TRANS/WP.29/650
16 February 1999

DRAFT SUPPLEMENT 2 TO THE 03 SERIES OF
AMENDMENTS TO REGULATION No. 44

(Child restraints)

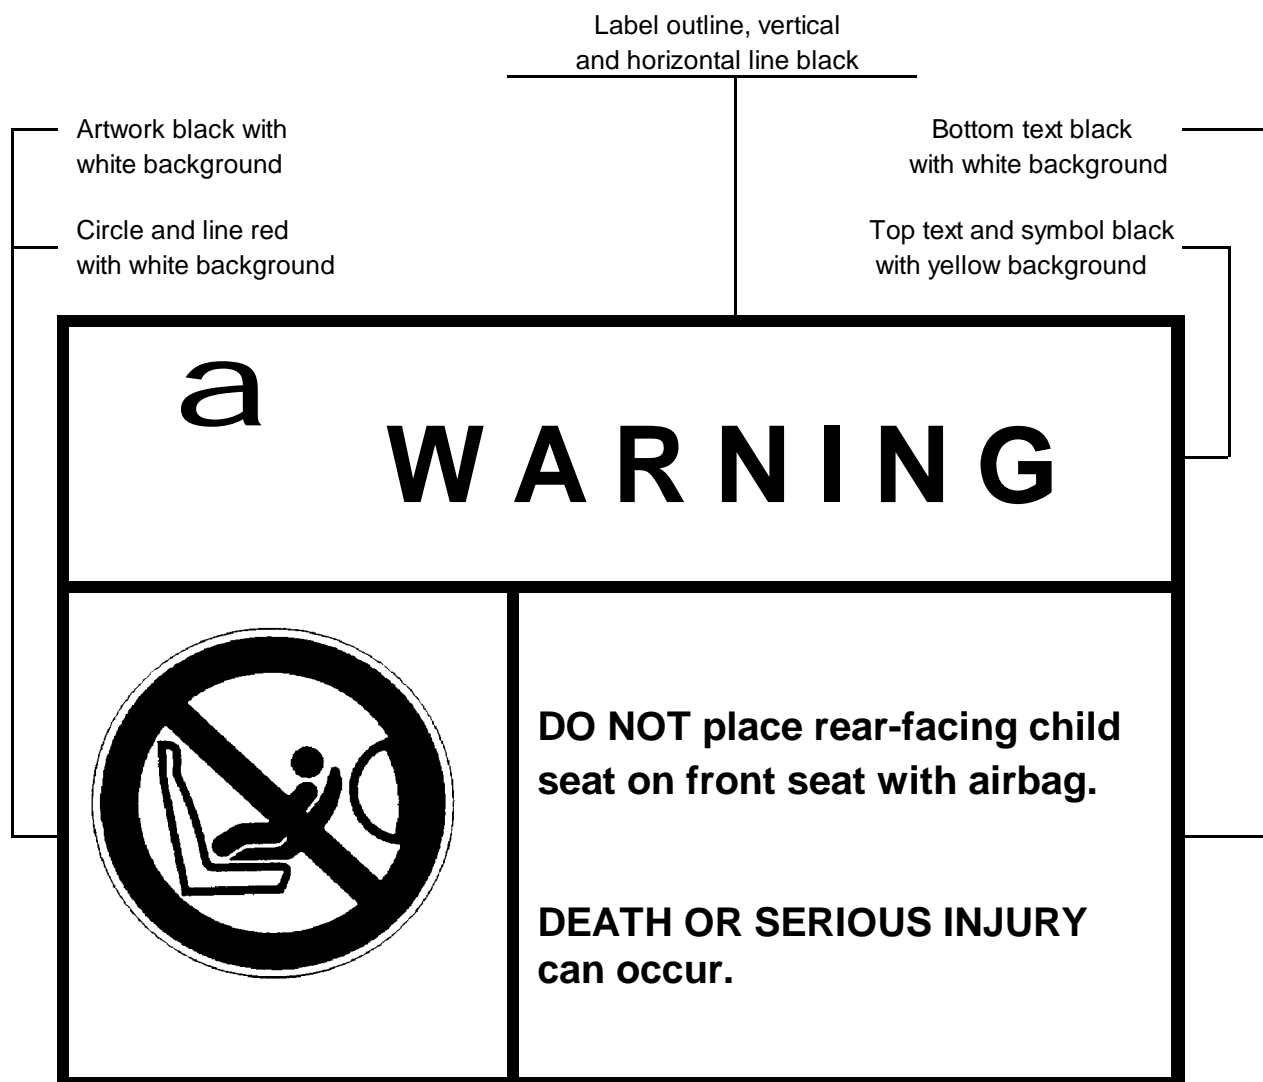
Insert a new paragraph 4.5., to read:

"4.5. In addition, in the immediate area where the child's head rests within the child restraint and on the visible surface of the child restraint system, rearward-facing restraints shall have the following label permanently attached (the text information shown is a minimum).

This label shall be provided in the language(s) of the country where the device is sold.

Label minimum size: 60 x 120 mm
